AIRWORTHINESS DIRECTIVE

Gippsland Aeronautics GA8 Series Aeroplanes

**AD/GA8/5
Amdt 1**

Horizontal Stabiliser Inspection

Figure 1 - Horizontal Stabiliser Attach Bolt

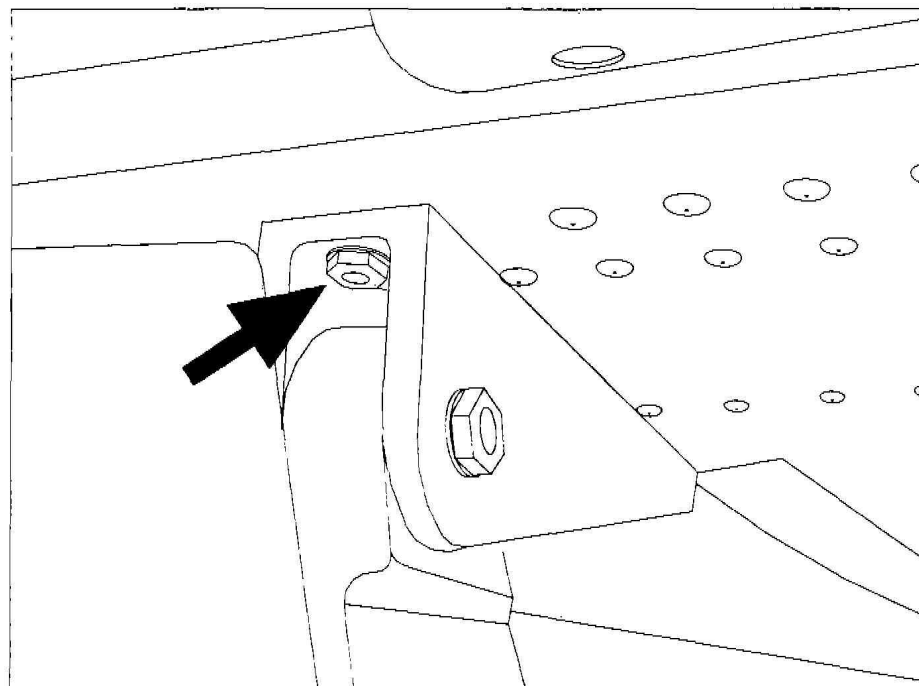
Visually inspect the integrity of the rearmost vertical Horizontal Stabiliser attach bolt and nut on both left and right sides, see Figure 1 below. This inspection can be carried out externally to the aircraft without removing any fairings or structure.

- (a) Remove the rearmost vertical Horizontal Stabiliser attach bolt and nut from both left and right sides as indicated in figure 1.
- (b) **Ensure the bolt and nut mating faces are square.** Spotface either side as required.
- (c) Install new **NAS6603-8** bolt and MS21042-3 nut. Ensure both bolt and nut sit square to surrounding material. Use AN960-10 washers under the nut as required. Torque bolts to 20-25 in lb. Follow instruction as recommended by AC43.13-lb, Section 7.40 in torquing bolts with friction locking nuts.
Caution - do not over torque the bolt.
- (d) Compliance with this part and part 3 (Rear Pivot Attachment Inspection) cancels the requirement to perform the Daily Visual Inspection of this area.

Figure 2 - Rear Pivot Attachment

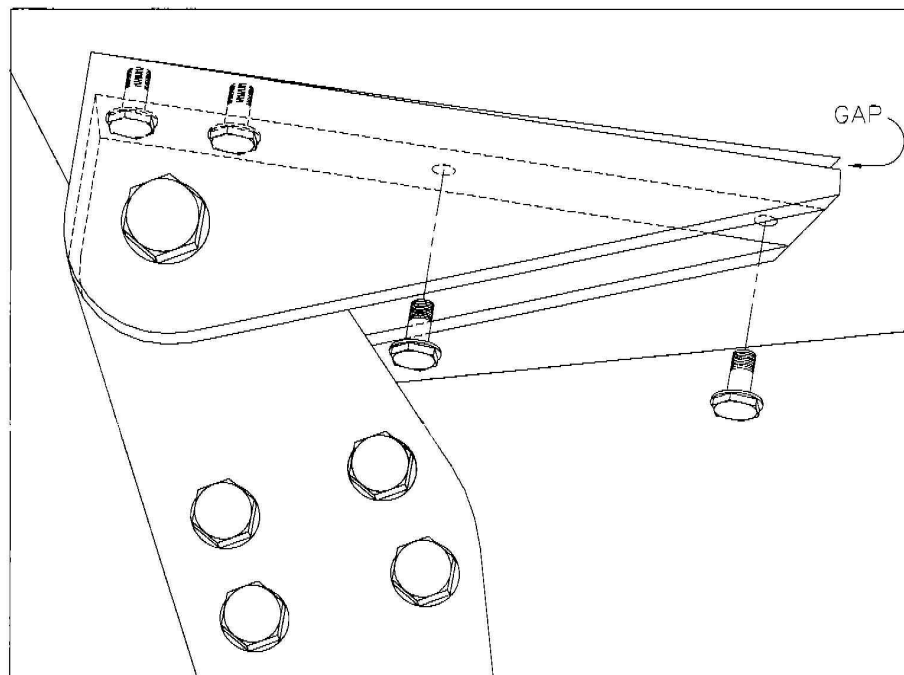
- (a) Remove the lower Horizontal Stabiliser fairings.
- (b) Unscrew the two front bolts from each pivot attachment, leaving the rear two bolts done up tight, as shown in Figure 2 below. Anchor nuts were used to retain these bolts on early aircraft. Later aircraft have loose nuts and washer, access to which can be gained through the upper Horizontal Stabiliser access panel.

- (c) If a gap appears, as indicated in Figure 2 above, manufacture a tapered packer from 2024-T3 Aluminium sheet metal, 1.25" wide and as long as required to fill the gap.

- (d) Coat the packer with suitable primer and paint, as specified in the GA8 Service Manual.
- (e) Install the packer and reinstall bolts. Torque bolts to 20-25 in lb. Follow instruction as recommended by AC43.13-lb, Section 7.40 in torquing bolts with friction locking nuts.
- (f) Replace the lower Horizontal Stabiliser fairings.

Figure 3 - Access hole

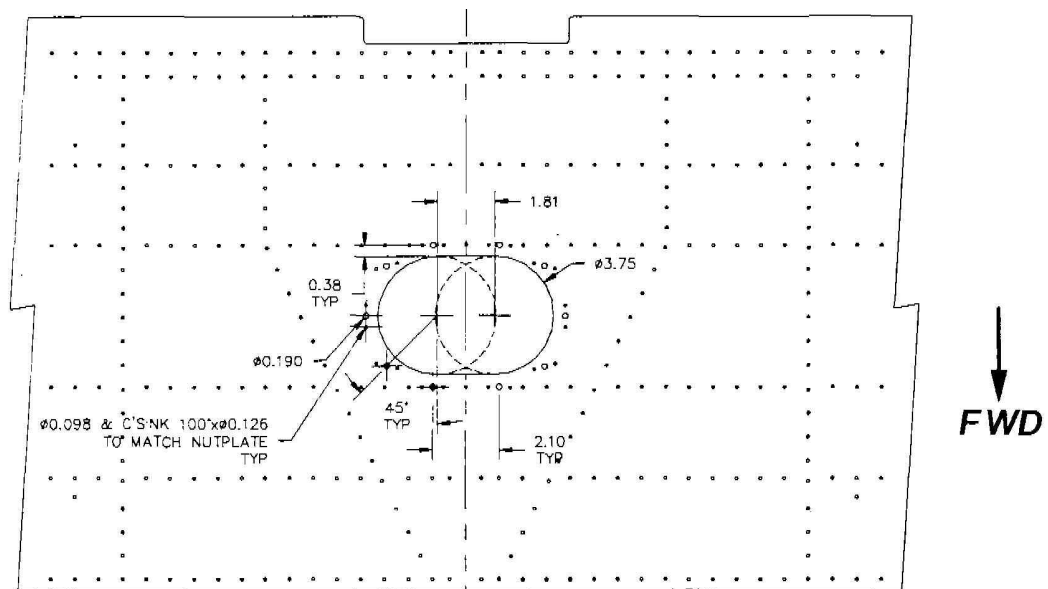
- (a) Remove the upper Horizontal Stabiliser fairings.
- (b) If the Horizontal Stabiliser contains a centreline upper skin access panel, remove the panel and skip to part (e).
- (c) Unscrew the lower Horizontal Stabiliser fairings. Disconnect the control cables from the Rudder and the pushrods from the Elevators. Remove Dorsal Fin and disconnect Fin electrical wiring. Remove the Rudder and then the Fin. Restrain the Elevators in the neutral position and carefully remove Horizontal Stabiliser/elevators assembly from the aircraft.
- (d) Cut an access hole as per the figure 3 below.

Figure 4 - Access hole with anchor nuts installed

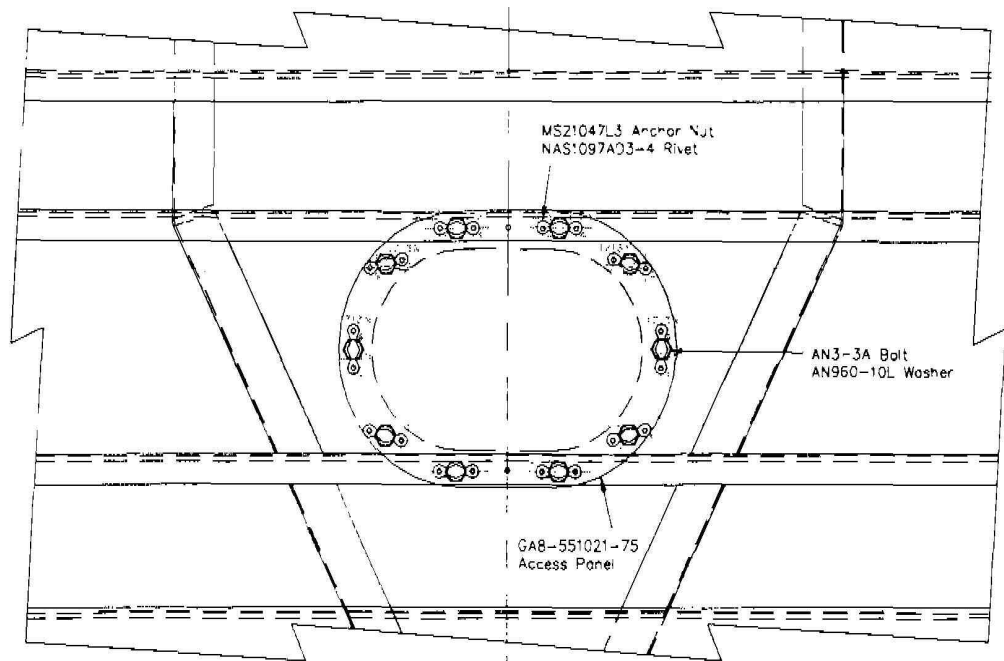
- (f) If cracking is found, contact the manufacturer immediately.
- (g) If no cracking is found, attach anchor nuts as per the figure 4 below. Attach access panel with bolts (or screws) and washers specified.
